Clonburris T3

Road Safety Audit Response Report

CLB-T3-ZZZ-SW-DTM-RP-DBFL-CE-0005

April 2023

Location (G1) – Dropped Kerbs and Tactile Paving Problem

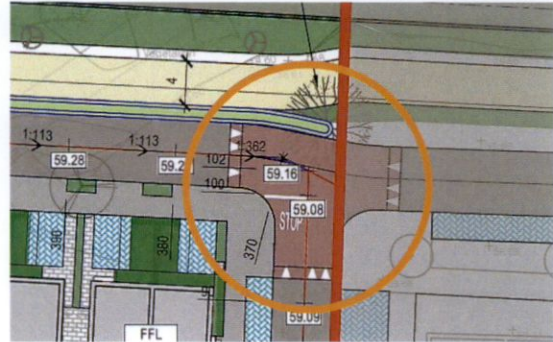
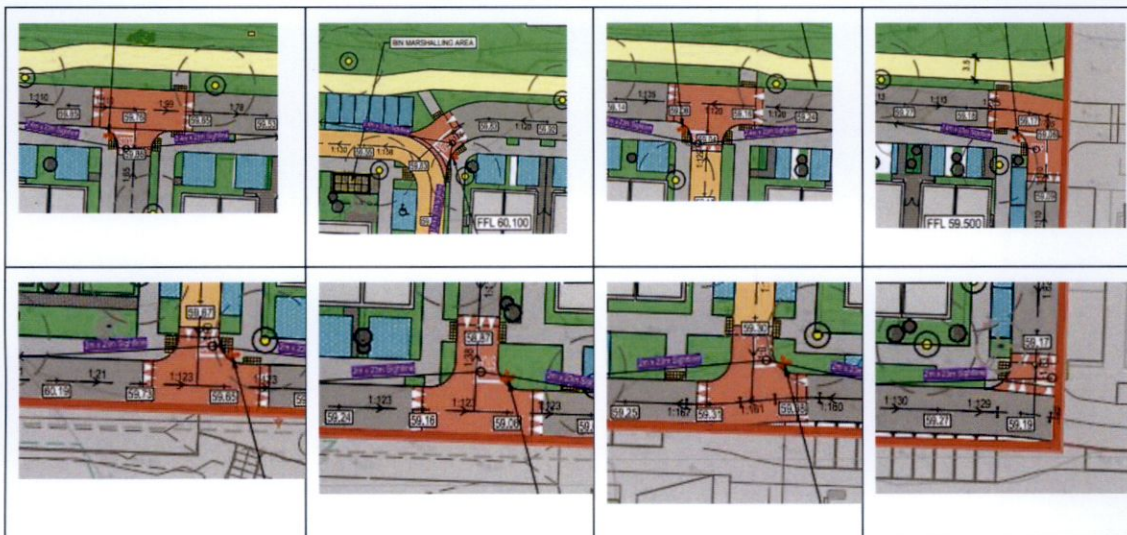
The drawings provided for the purpose of the RSA do not show provision of dropped kerbs and tactile paving at certain locations where pedestrian crossing points are proposed. This could lead to accessibility issues for road users, particularly wheelchair users and can cause confusion for partially sighted pedestrians who may encounter difficulties when crossing the road carriageway.

It is recommended that dropped kerbs and / or tactile paving in accordance with the appropriate design recommendations is provided at all key pedestrian travel desire lines that require a pedestrian to cross a road carriageway.

Pedestrian road crossing points and tactiles at all appropriate locations have been added to ensure safety of regular and disabled pedestrians. Key pedestrian desire lines have been considered at intersections and as close as possible to the middle of residential housing blocks.

Location (G2) – Crossing Alignment with Footpath

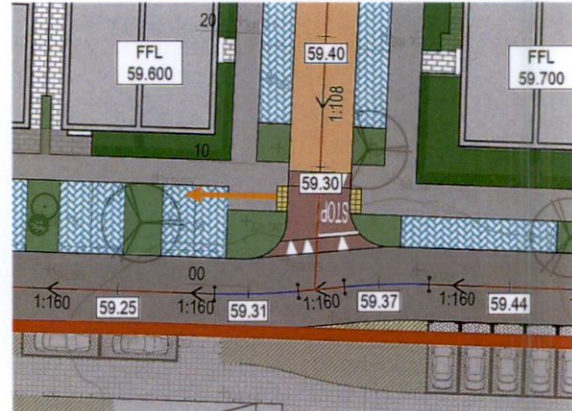
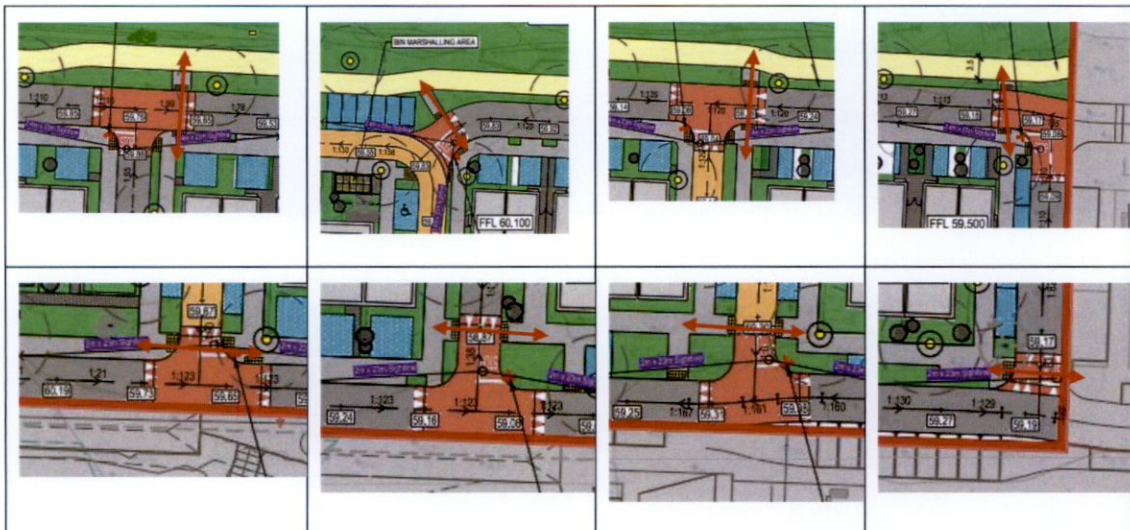
The auditors note that proposed pedestrian crossings at some instances have not been aligned with footpaths on both sides of the crossings such as shown in the figure opposite. This may direct visually impaired pedestrians toward car parking bays resulting in a conflict between pedestrian and vehicles.

Ensure pedestrian crossings are appropriately aligned with the footways on both sides to safeguard the safety of visually impaired pedestrians.

All pedestrian crossing points, including the crossing at the junction of streets 12 and 18 have been aligned with footpaths to avoid any pedestrian confusion.

Location (G3) –Signage

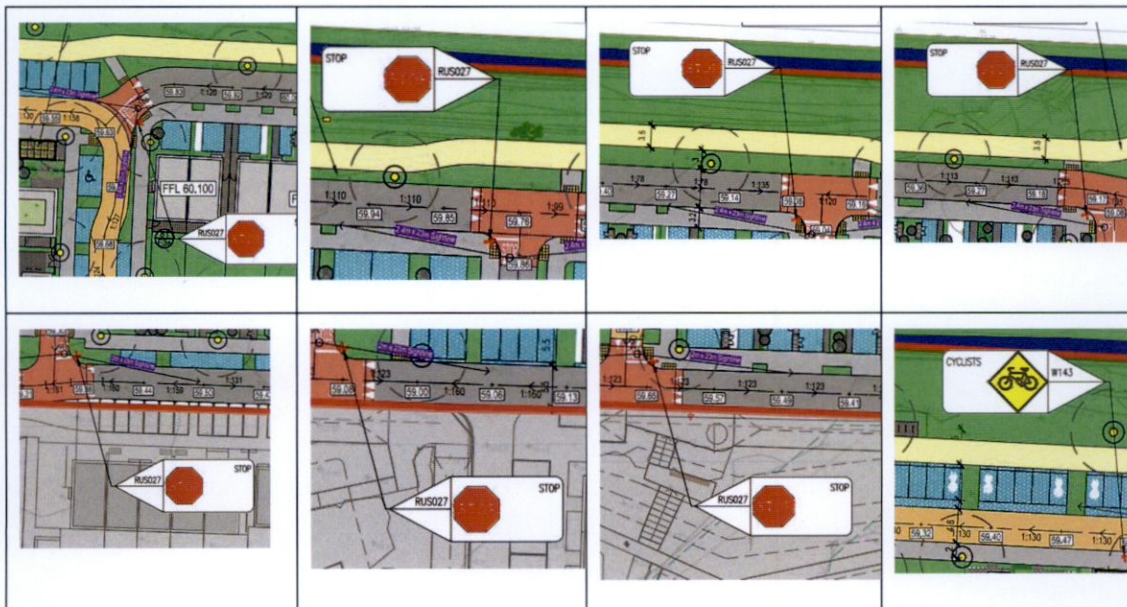
The drawings provided for the purposes of the RSA do not show details of signage. Failure to provide the appropriate regulatory signs may result in vehicles failing to stop at the minor arm of

junctions which may lead to side impact collisions with vehicles travelling along the major arm through junctions.

It is recommended that appropriate road marking and signages are provided in accordance with the requirements of the Traffic Signs Manual.

Proposed signage has been added to the roads layout drawing CLB-T3-95-SW-DTM-DR-DBFL-CE-1201 in accordance with the Traffic Signs Manual.

Location (G5) – Waste Bin Service Arrangement

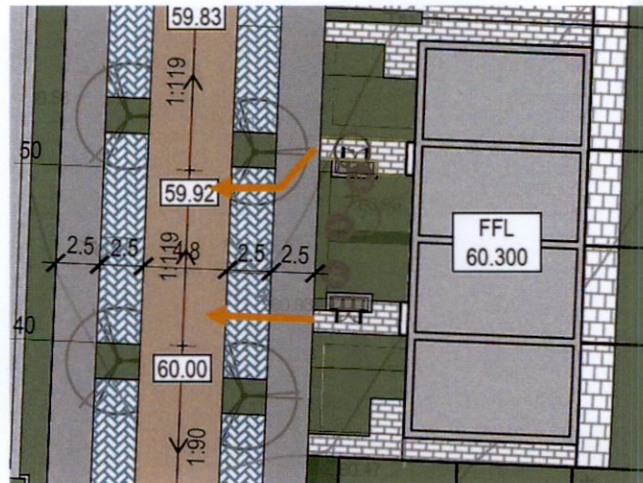
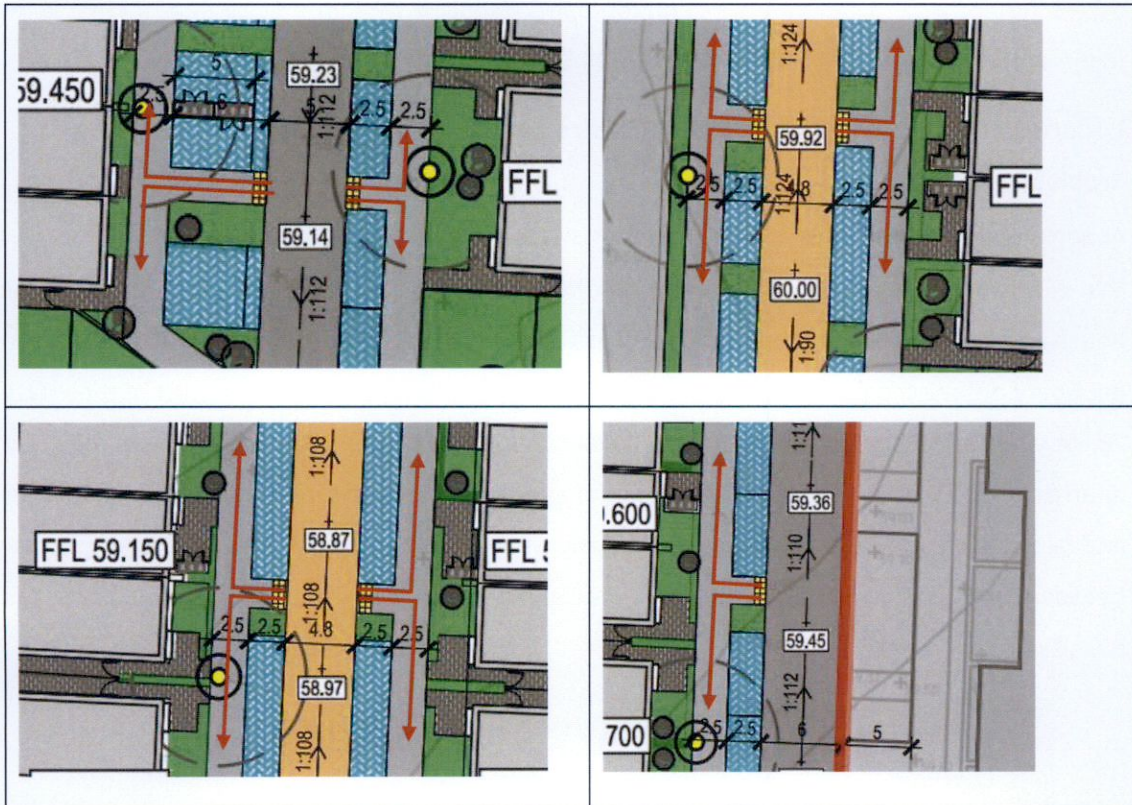
The auditors note that the drawing illustrates the locations of waste bin storage areas within the site. However, the transfer arrangements for the waste bins between the carriageway and the house units is unclear. Should waste bins be inappropriately stored in the path of pedestrians, this could block pedestrian routes or limit the space available to pedestrians as they could

step onto the adjacent landscaping area or onto the parallel parking bays. This could result in pedestrian / vehicle conflicts. No consideration has been given to waste collection services requirements to transfer (e.g., manually pull the bins via the footpath and between the parallel parking bays) the waste from the storage area. If parking bays are occupied by vehicles, no route would be available when transferring bins to / from the waste collection vehicle on the carriageway.

Ensure appropriate bin transfer areas / locations and appropriate routes are be provided for waste bin transfer which do not result in the reduction of footpath widths to such an extent that pedestrian must leave the footpath to move around bins. Ensure a navigable route in the form of an appropriately designed pathway is provided that offers a route for waste collection activities on the carriageway.

Footpath connections between the footpath and the roadway have been added after the road safety audit as stated in the audit responses. Further pedestrian links have been added closer to

the middle of the streets to allow a link from the houses to the road for bin collection. Refer to drawing CLB-T3-95-SW-DTM-DR-DBFL-CE-1201 for further details.

Location (G8) - Long Straight Sections of Carriageway

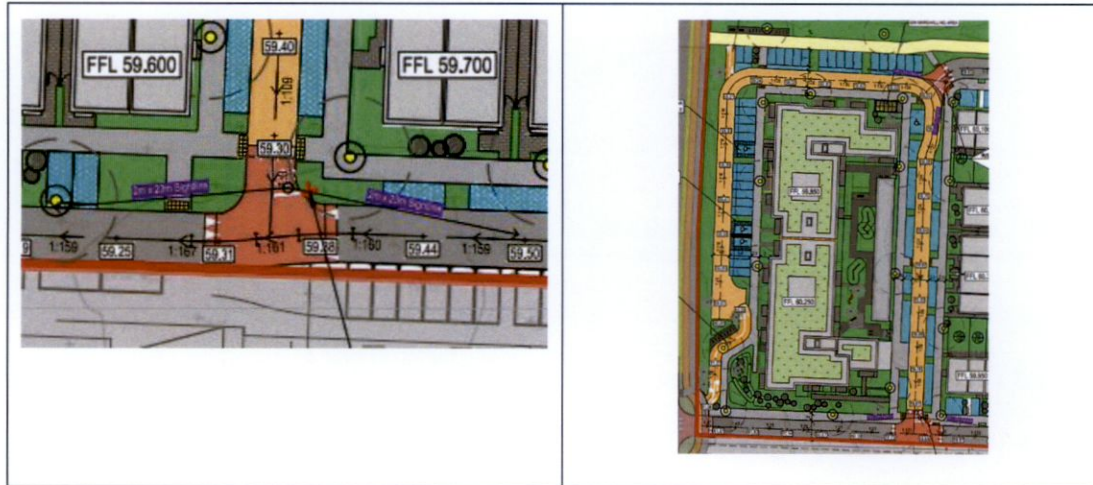
The internal local roads exhibit long straight sections with the carriageway lacking necessary traffic calming measures. This could lead to high excessive vehicle speeds. Higher speeds would lead to higher severity injury collisions should a driver lose control or come into contact with another road user.

The designers are requested to confirm the adopted design speed for each of the development streets. It is recommended that suitable traffic calming measures are provided to manage vehicular speeds along the local road/streets and ensure vehicle drivers do not exceed the adopted design speed. The measures should be in compliance with the principles set out in DMURS in regards to managing vehicle speeds.

The design speed of the development is 30km/h. Several bends in alignment have been introduced in Local Streets and different carriageway treatment utilised in Home Zones to manage vehicle speeds. Additional raised intersections and pedestrian crossings have also been introduced to

address auditors concerns. Traffic signage will also be used to mitigate speeds along the streets within the development.

An additional raised table has been added to manage vehicle speeds and Street 14 has been turned into a 4.8m wide Homezone. Refer to drawing CLB-T3-95-SW-DTM-DR-DBFL-CE-1201 for further details.

Location (G9) – Cycle Parking

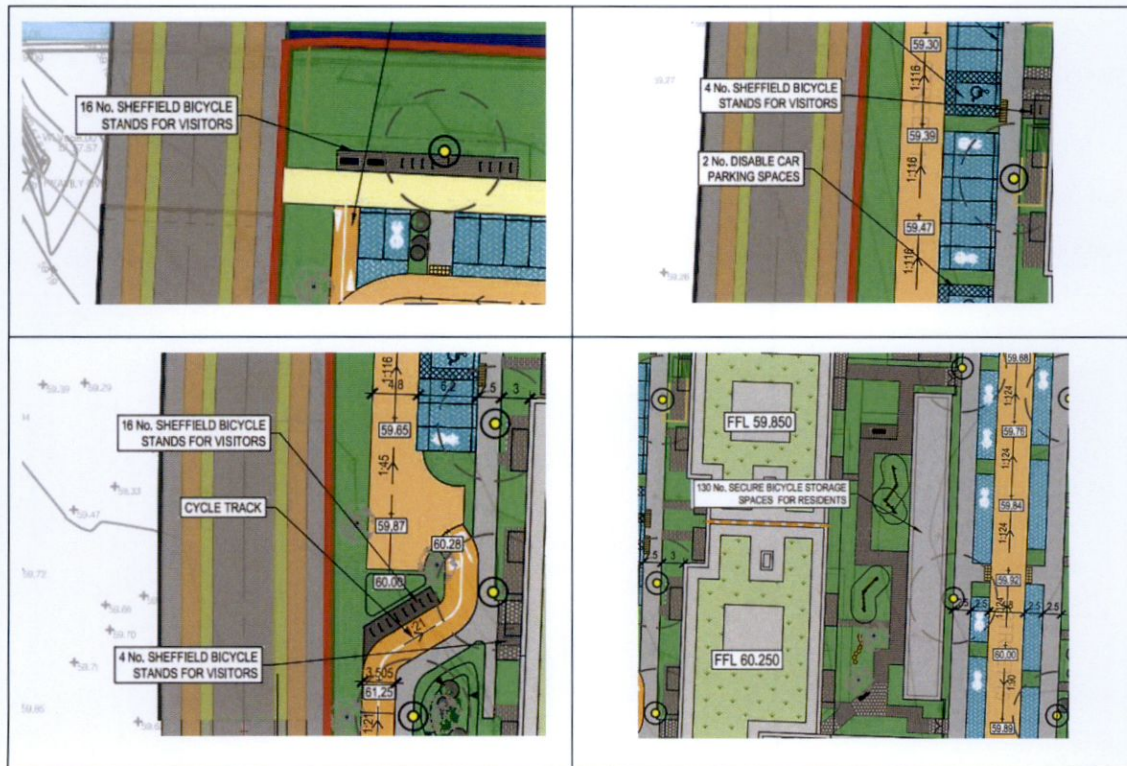
The auditors note in reference to the drawing provided for the purpose of the audit that no long term (residents) or short term (visitors) bicycle parking has been provided. The auditors are concerned that in the absence of such facilities indiscriminate bicycle parking practices (eg. Light poles etc) may arise which have the potential to block the footpath and represent trip hazard for pedestrians.

The designer should ensure that the appropriate quantum of bicycle parking is provided for both resident and visitors. The design and location of the bicycle parking should respect the appropriate design guidance and safeguard pedestrian routes free from trip hazard.

Long term and short stay bicycle parking is now shown on the roads layout CLB-T3-95-SW-DTM-DR-DBFL-CE-1201 and corresponds with requirements as stated in the TTA.

Location (G10) – EV Parking

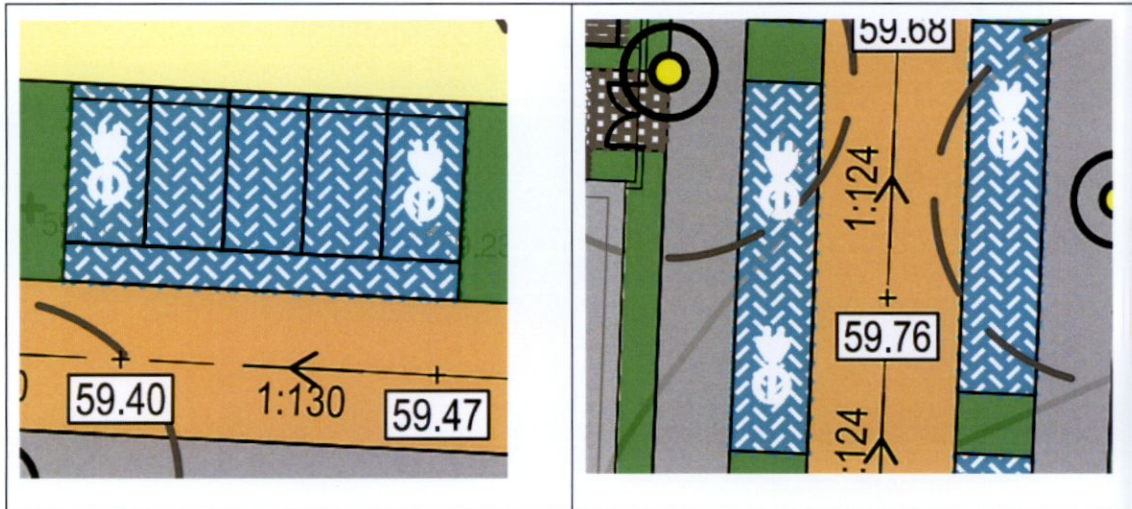
It is noted upon review of TTA report that a minimum of 34 no. electric vehicle (EV) parking spaces will be provided. However, the scheme does not provide details of the location and size of EV parking bays or the location of EV charging points. The auditors are concerned that the proposed EV parking bays may be of a substandard size that could impact accessibility and result in cables encroaching to the public footpath which would represent trip hazard. Furthermore, the auditors are concerned that EV charge point may be located in either 1) the public footpath which could subsequently represent obstruction and /or 2) a grass landscaped area which, particularly in wet conditions, could be slip hazard for drivers seeking to access the charge point.

The designers are requested to confirm the location and size of all EV parking spaces meet best practice design guidance. EV charging points should be located in an area of hard standing, outside of the footpath area, and in close proximity to EV bays.

EV parking spaces are minimum 5.5m in length and are indicated on the roads layout CLB-T3-95-SW-DTM-DR-DBFL-CE-1201.

All footpaths proposed as part of the development have been increased to 2.5m wide if they were not previously. This would provide enough space for pedestrians on footpaths even if EV charging stations are placed on the edge of footpaths.

Location (G11) – Visibility Splays at Junction

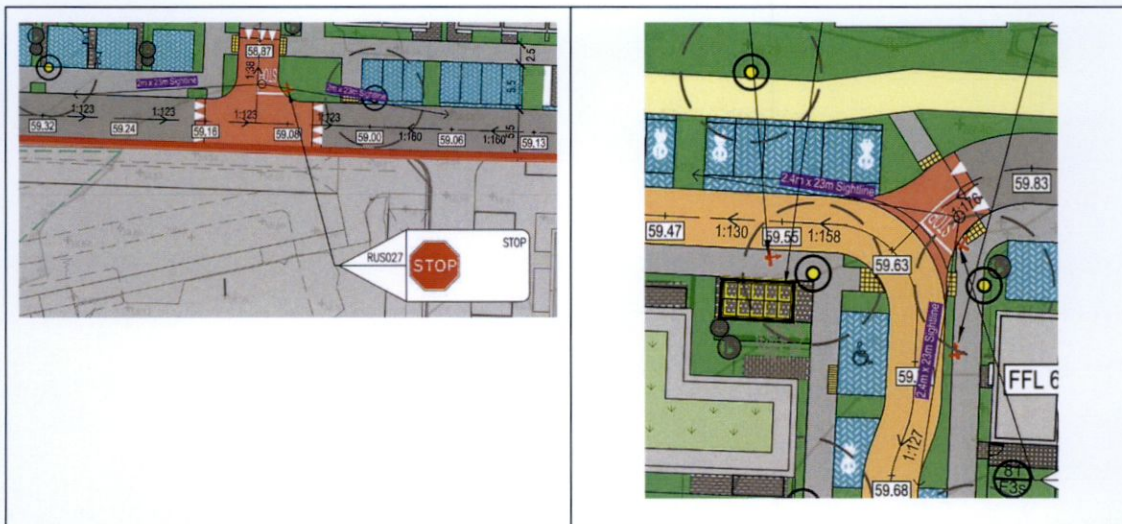
The proximity of car parking bays adjoining a number of internal junctions throughout the site may obstruct driver's visibility. Failure to provide sufficient visibility for vehicle drivers at the junctions could result in overshoot incidents or side impact collisions with vehicles/cyclists travelling along the road.

Ensure sufficient visibility is provided at all junctions and vehicle access points as outlined in DMURS by ensuring car parking and tree species are located /specified such that unobstructed visibility splays safeguarded.

Visibility splays have been indicated on the roads layout CLB-T3-95-SW-DTM-DR-DBFL-CE-1201 to ensure there are no obstructions to any vehicle sight lines at junctions

Location (S1) – Mobility Impaired Parking Bay

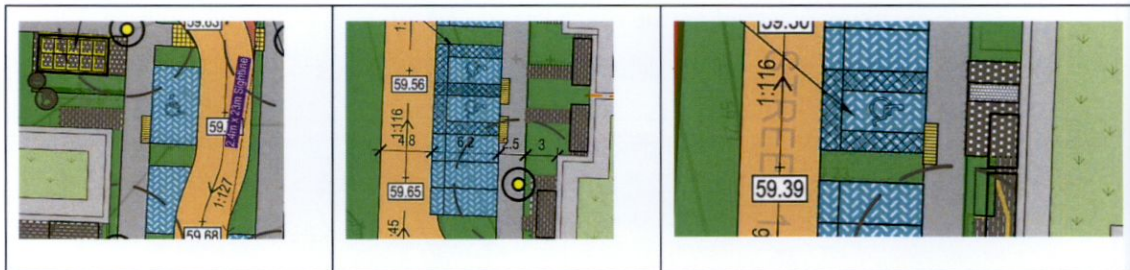
The mobility impaired parking bays are proposed to adjoin the landscaping area that does not provide a hardstanding area or dropped kerbs. A disabled person may find it difficult when entering / egressing the vehicle parked at this bay if a kerb is present which could result in a fall and cause an injury.

It is recommended that appropriate hardstanding areas with dropped kerb are provided to connect the parking bay with the footpath. The layout of 'parallel' disabled bay should respect the guidance outlined in the Traffic Signs Manual.

Dropped kerbs have been provided for all disabled parking bays to allow users to access the adjacent footpaths as per the Traffic Signs Manual. Refer to the roads layout CLB-T3-95-SW-DTM-DR-DBFL-CE-1201.

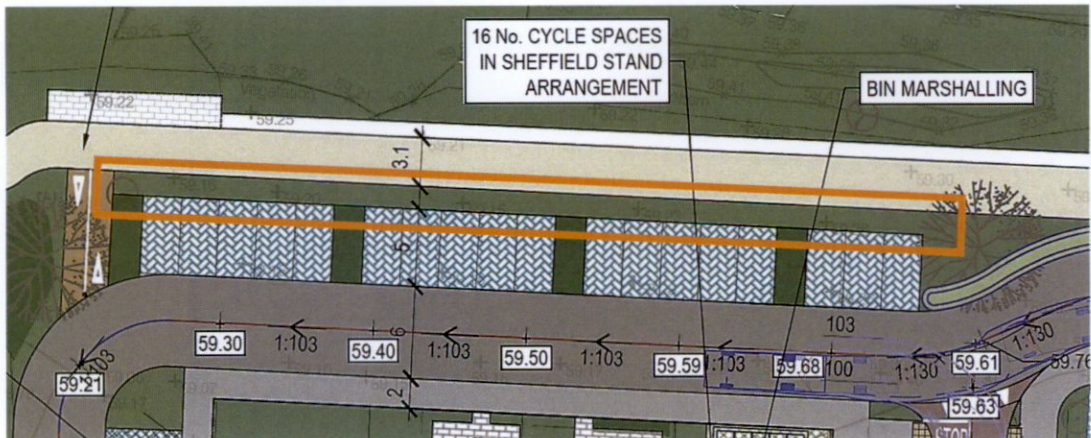
The two-way cycle track could commence / terminate further south to ensure that a reversing vehicle does not need to drive onto the cycle track.

The roadway could not be extended as suggested as the cycle link to the south would no longer meet part M gradient requirements. Parking bays were however moved farther north and a hammerhead has been introduced to assist vehicle turning and create a safe tie-in space for the cycle track to the roadway.

Location (S4) – Parking Bay and Pedestrian / Cycle Facility Connection

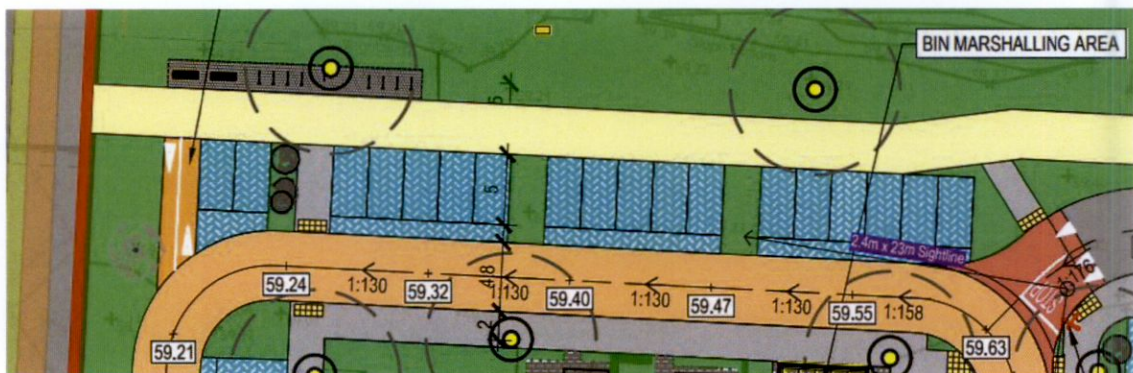
No connection has been provided between the parking bays (located north of Block B) and the continuous pedestrian / cycle link at the northern boundary of the site. The parking bay and the pedestrian / cycle link has been separated by a landscaping strip. The landscaping strip could be a trip hazard for pedestrians particularly during wet conditions.

It is recommended that a concrete handstand be provided to ensure the shared pedestrian / cycle link is easily accessible by individuals accessing / egressing their vehicles.

The landscape strip between the parking bays and the shared pedestrian/cycle route has been removed to ensure easy access from the parking area and eliminate any trip hazard.

Location (S5) – Tactile Paving

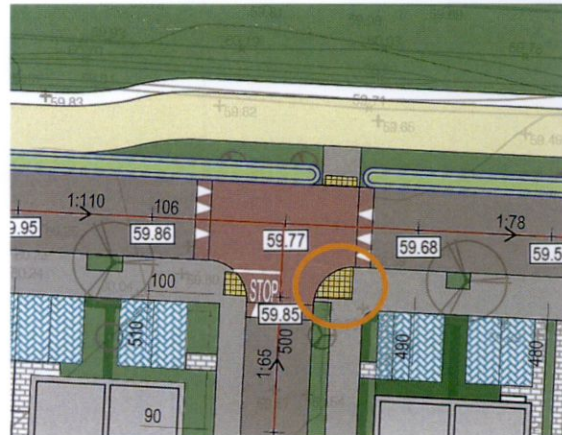
The tactile paving on the eastern edge of the minor arm is misleading and would currently direct visually impaired pedestrians towards the carriageway resulting in collisions .

Ensure tactile paving is appropriately placed . A separate tactile paving should be provided for north-south movements at the eastern arm of this junction.

Separate tactiles have been provided for the north-south and east-west pedestrian routes to avoid any confusion of visually impaired users of the footpaths.

Location (S7) – Lack of Vehicle Turning Head

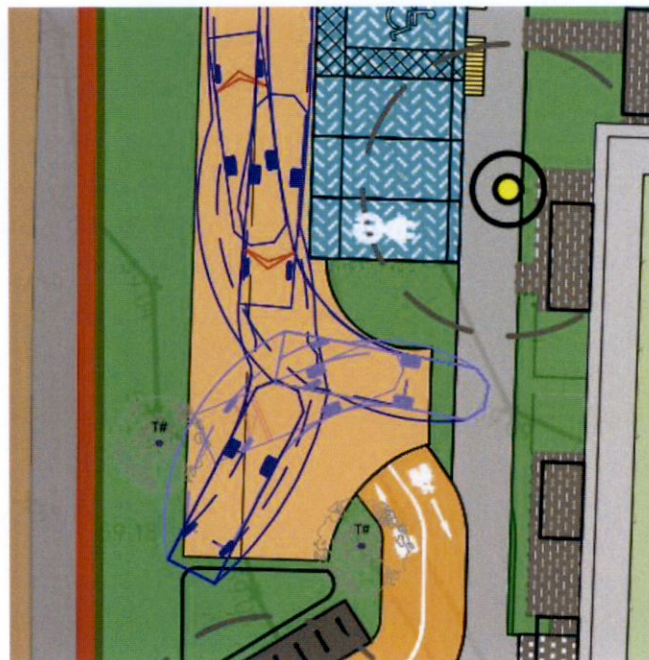
It is unclear how cars and large refuge vehicles will be able to access and undertaking u turn manoeuvre at the southern termination of the north-south street located immediately to the west of apartment block at the western edge of the site. The auditors request clarification regarding how large vehicles can be accommodated as the road terminates with a cul-de-sac.

To ensure a safe and convenient turning movement at this location, it is recommended to provide a turning head on this carriageway.

A turning head has been added to the end of Street 14 to allow sufficient turning space for a fire tender vehicle. Refer to drawing CLB-T3-95-SW-DTM-DR-DBFL-CE-1202 for further vehicle tracking details for the site.
